EXXEL PACIFIC
GENERAL CONTRACTORS

Request For Information - 054

The Cora Apartments (19 W Harrison)

Subject:	**ADA Clearances in Kitchens & Bathrooms, Grab Bars**	**Status:**	**Open**
Drawing #:	A0201, A0202, A0204, A0611, A0613, A0615, A0616, A0617, ID302, ID319	**Spec Sect #:**	
Addendum:		**Submittal #:**	12 3000-03 R1 Manufactured Casework for Units - Shop Drawings

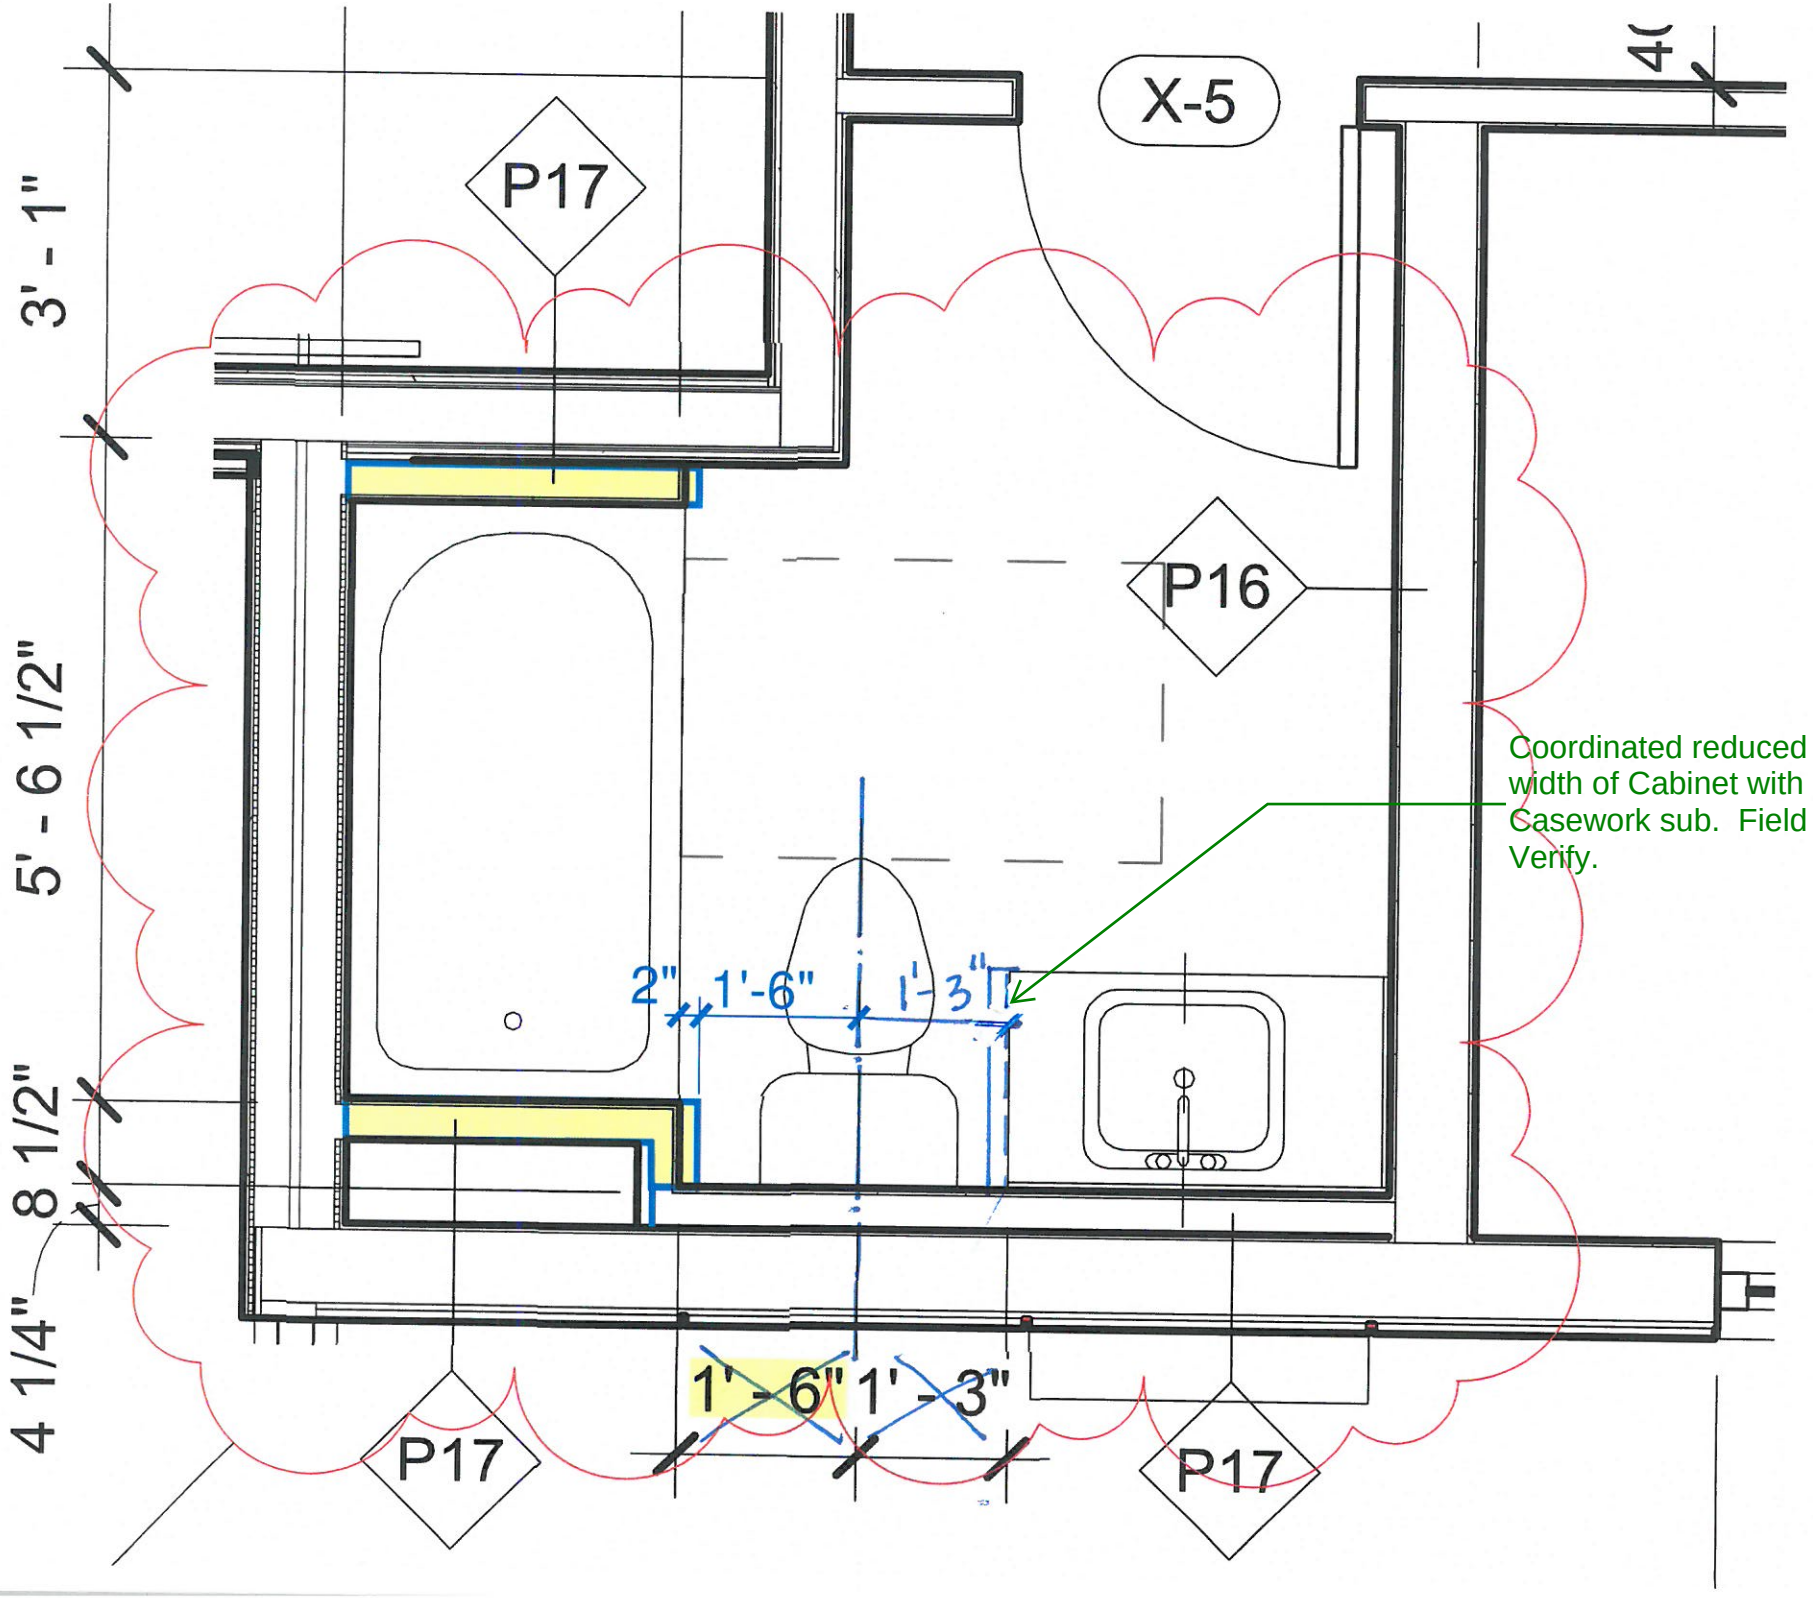
Please see the attached marked up bathroom plan at Unit type F. The sub will need an extra 2" of the wall space for the tub installation (to allow for the flange). We have a few cases like that, Unit F is just one example. Please verify if the required 1'-6" is measured from the edge of the tub or from the wall (at 2" projection) to the centerline of the toilet.

X-5
P17
P16
P17
P17
3' - 1"
5' - 6 1/2"
8 1/2"
4 1/4"
2"
1'-6"
1'-3"
1' - 6"
1' - 3"
Coordinated reduced width of Cabinet with Casework sub. Field Verify.

Jola,
The Toilet would need to move (East) 2" and the Sink Cabinet would need to be reduced to a 36" Cab.
We have to maintain a 33" clear space for the Toilet wall, and the Toilet must be 16" away from the Tub wall.
Additionally the sink needs to be 24" from centerline to face of wall within the Cab.

Rm11 Unit H RefL
(2) SHOWN
Room # 11
Unit H 313 & 713

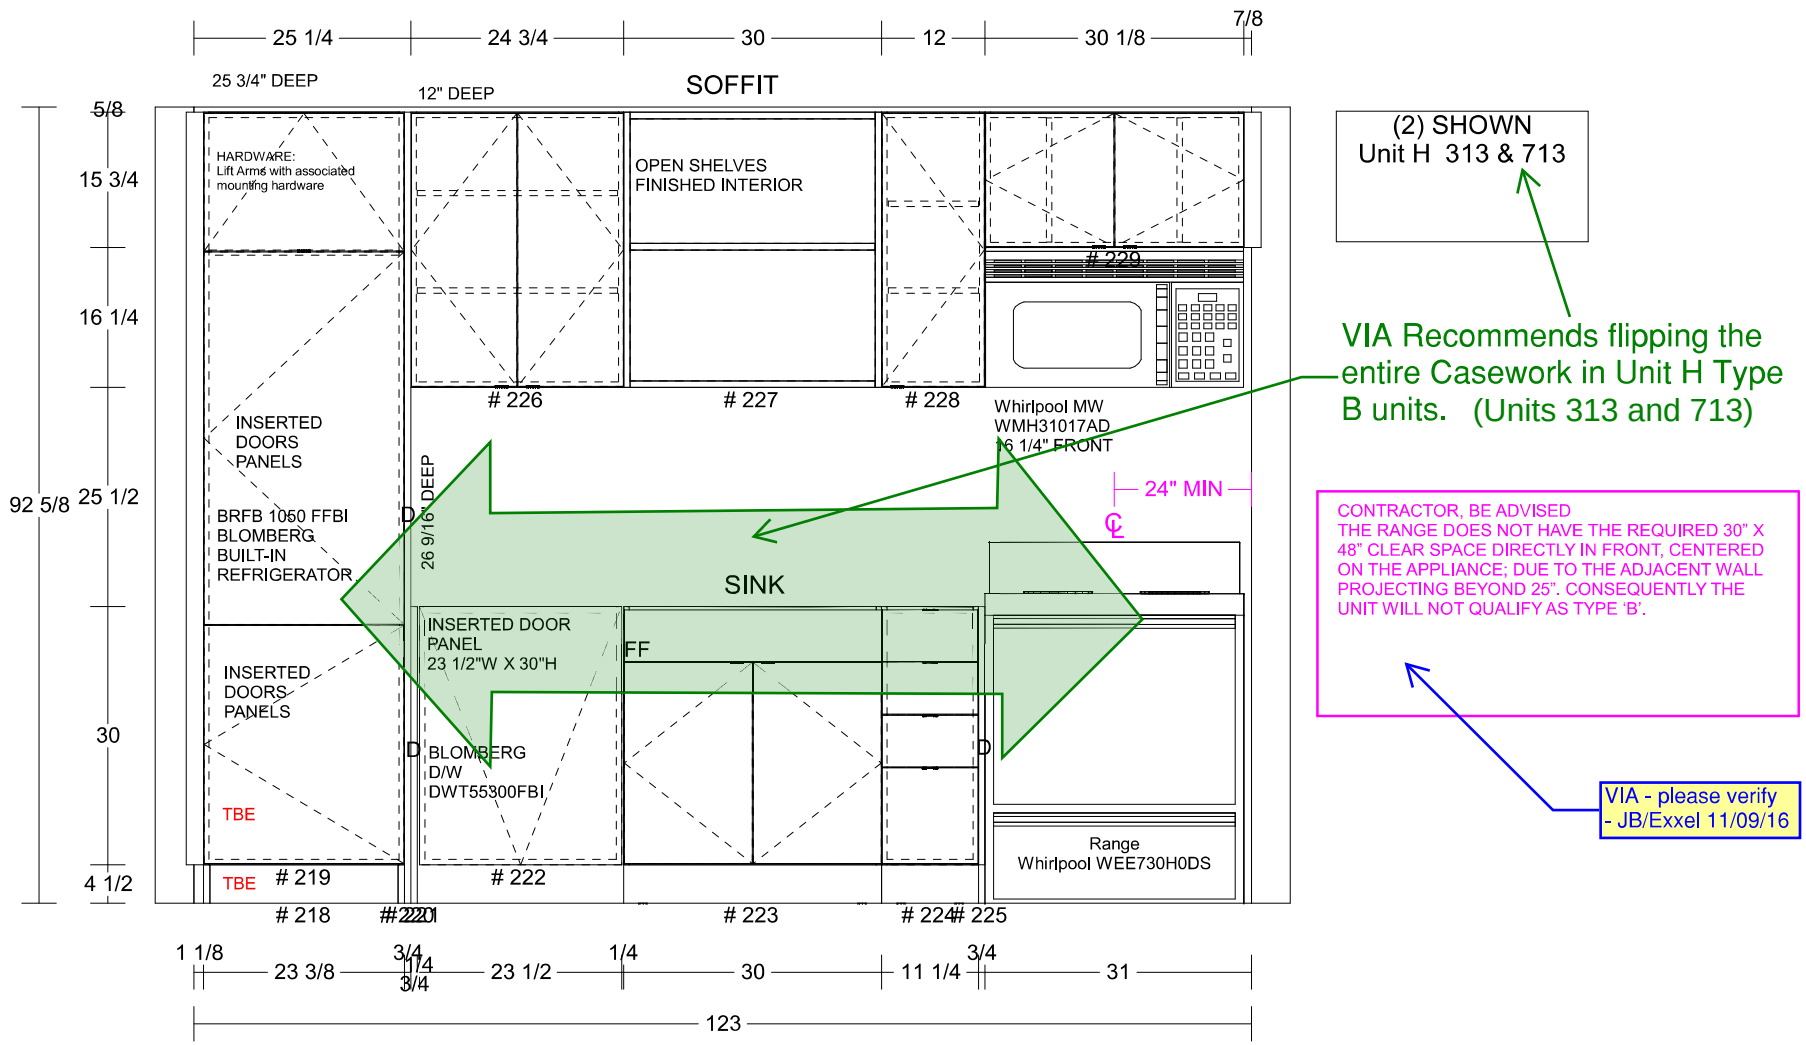
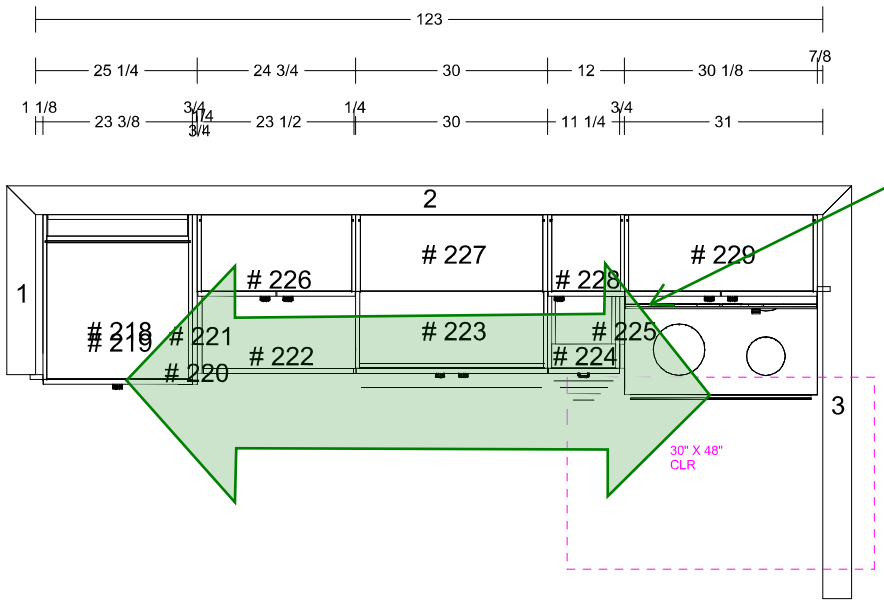
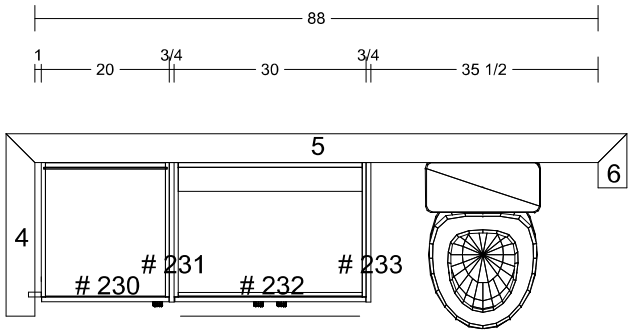
Per your comments on the cabinet shop drawings (12 3000-03 R1 Manufactured Casework for Units), please confirm that the entire Casework in Unit H Type B needs to be flipped to comply with ADA requirements at the Range 30x48 clearance box.

CONTRACTOR, BE ADVISED
THE RANGE DOES NOT HAVE THE REQUIRED 30" X 48" CLEAR SPACE DIRECTLY IN FRONT, CENTERED ON THE APPLIANCE; DUE TO THE ADJACENT WALL PROJECTING BEYOND 25", CONSEQUENTLY THE UNIT WILL NOT QUALIFY AS TYPE 'B'.

VIA - please verify
- JB/Exxel 11/09/16

Date	Response
11-29-2016	#1 - If wall at tube flange needs to move 2" into the required 33" clear space for the Toilet then the Toilet will need to move 2" toward the Cabinet and the Cabinet will need to be reduced in width by the 2" #2 - Owner has approved flipping the Type H Unit (Type B) kitchens due to required ADA clearances at the Range. (Units 313 and 713) #3 - No Grab Bars to be installed in the Type A Units. Wall blocking to be installed in all Units. #4 - Distance governed by Electrical code. Design Build Electrical sub to determine. JXW

VIA Recommends flipping the entire Casework in Unit H Type B units. (Units 313 and 713)

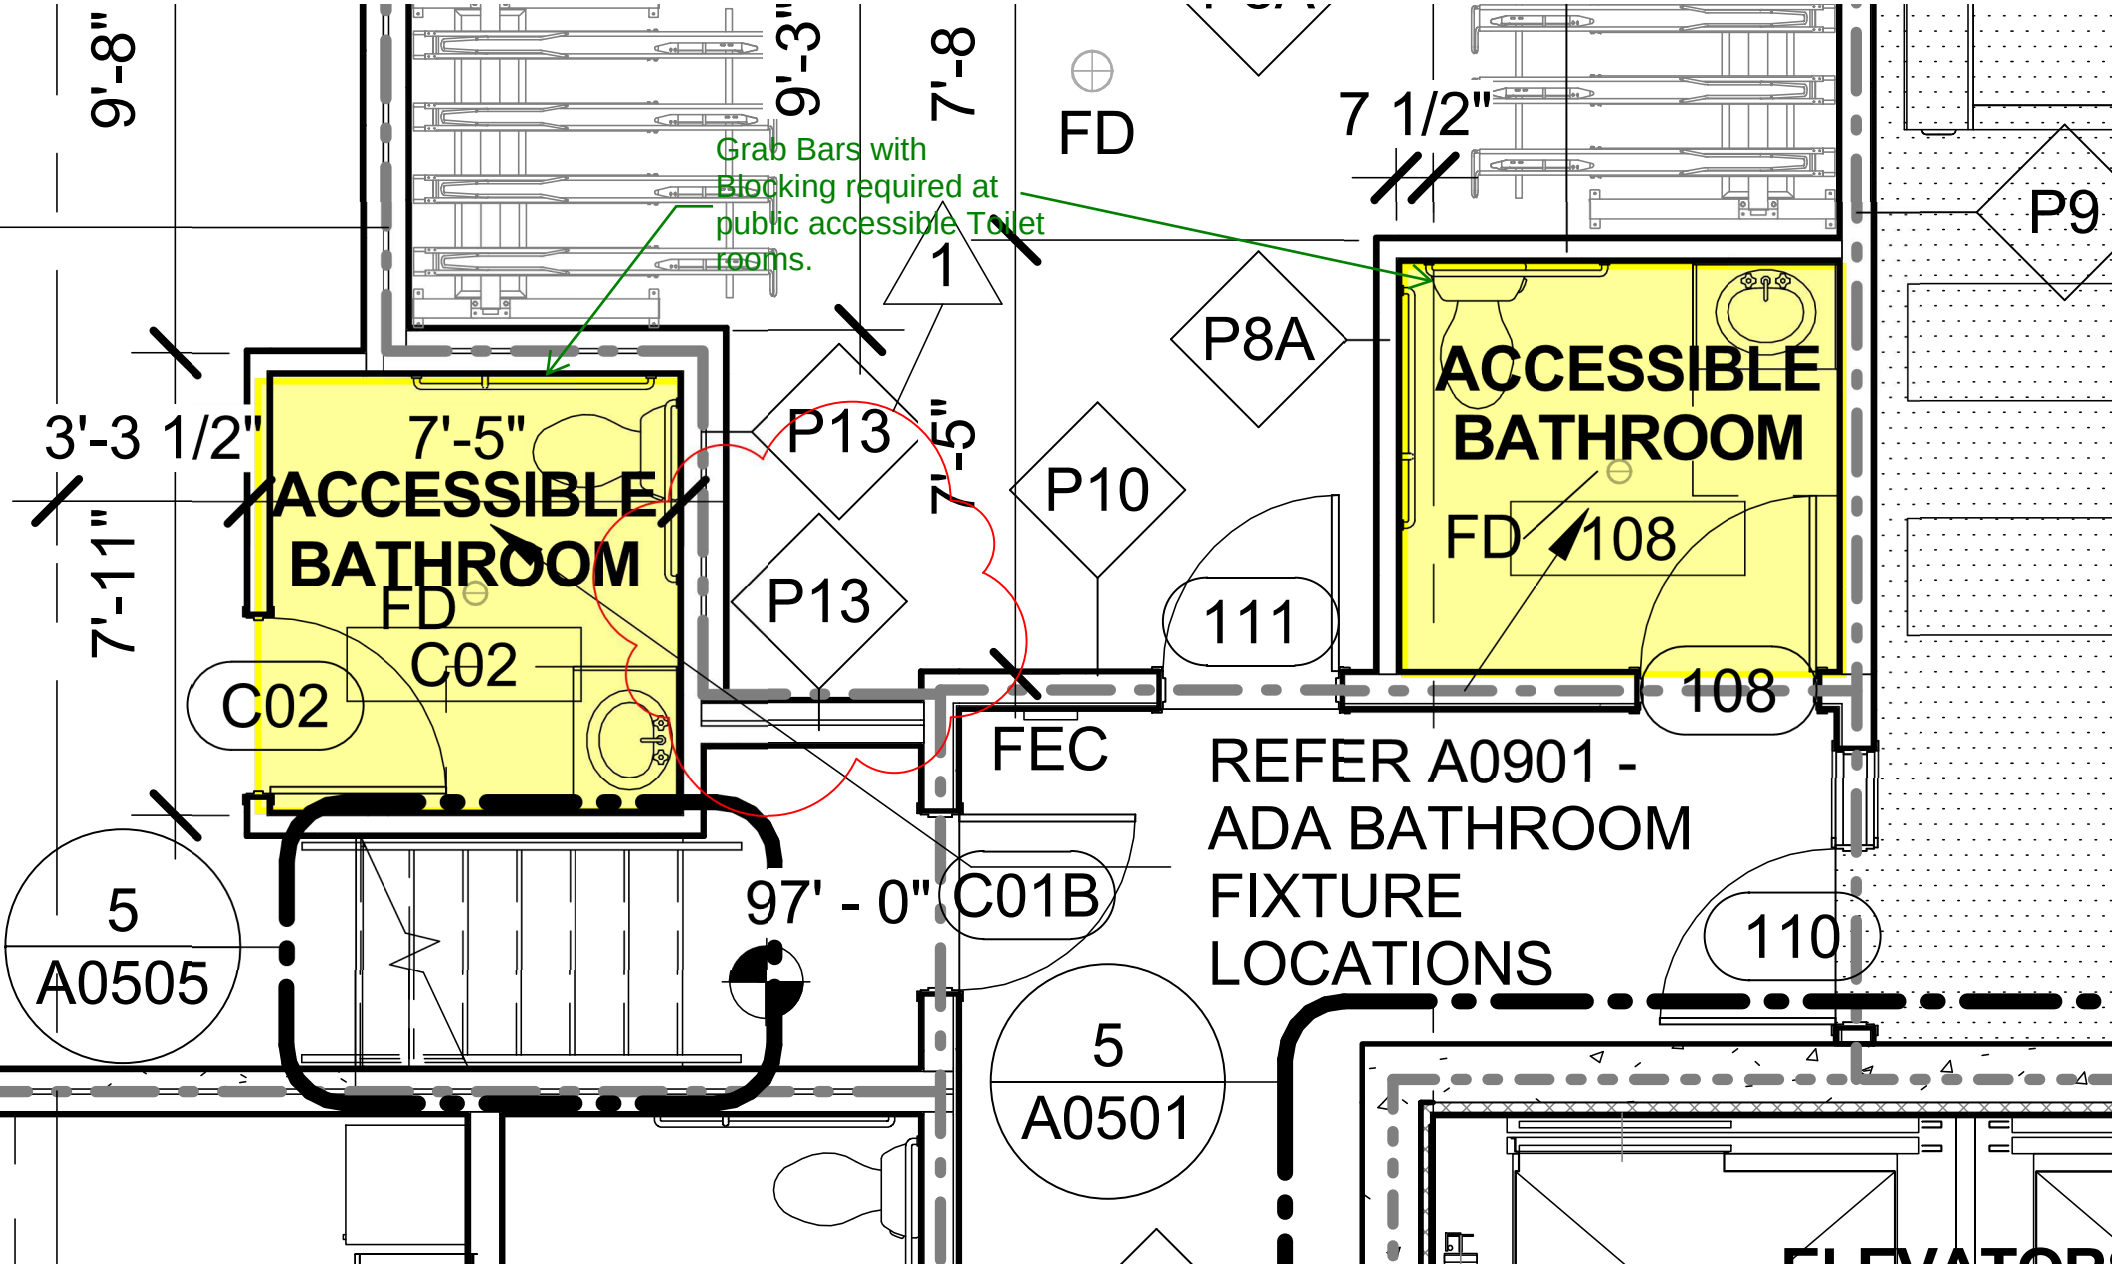
Please verify whether the grab bars have to be installed in the Units type A bathrooms, or just the in-wall blocking for the future installation, as shown on A0901. If the grab bars have to be installed in accessible bathrooms in the Retail space (C02) and in the Common Area (108), please provide the interior elevations showing the specific location.

9'-8"
9'-3"
7'-8
FD
7 1/2"
Grab Bars with
Blocking required at
public accessible Toilet
rooms.
P9
1
P8A
ACCESSIBLE
BATHROOM
FD
108
3'-3 1/2"
7'-5"
ACCESSIBLE
BATHROOM
FD
C02
C02
P13
7'-5"
P10
P13
111
108
7'-11"
FEC
REFER A0901 -
ADA BATHROOM
FIXTURE
LOCATIONS
5
A0505
97' - 0"
C01B
110
5
A0501

Grab Bars with Blocking required at public accessible Toilet rooms.

3 TYPICAL TYPE "A" BATHROOM FIXTURE LOCATIONS

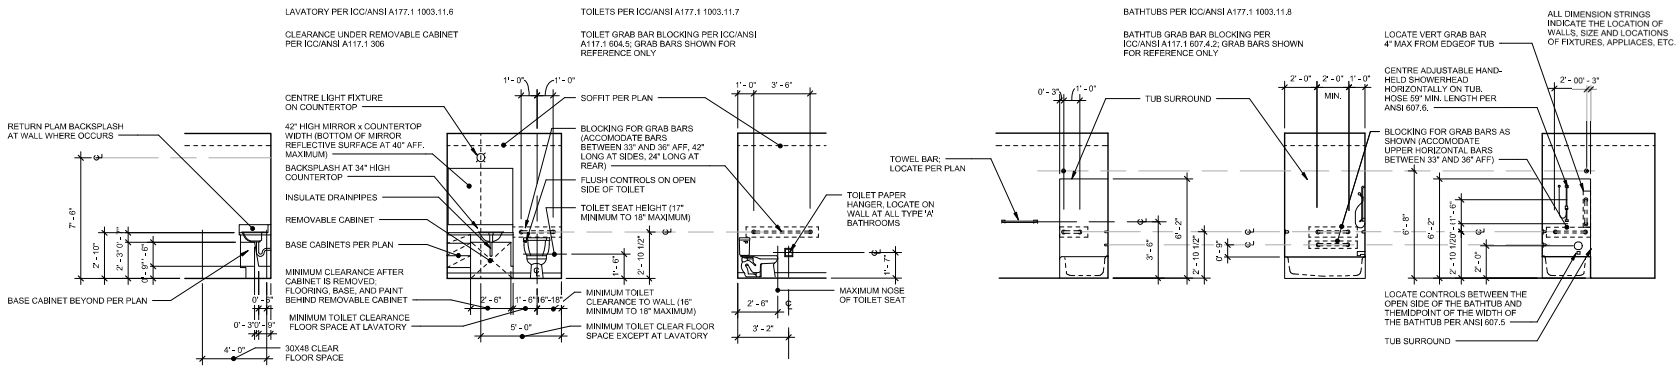
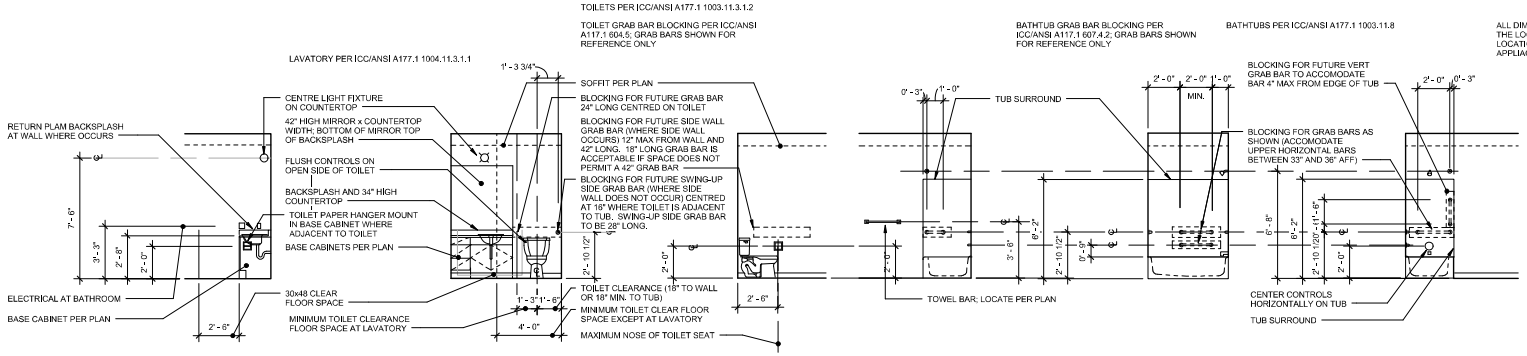
Per the e-mail from John W./VIA on 11/18-16, please confirm the distance from the wall projection (2" is needed for the tub flange nailing) to the centerline of the toilet in type B bathrooms.
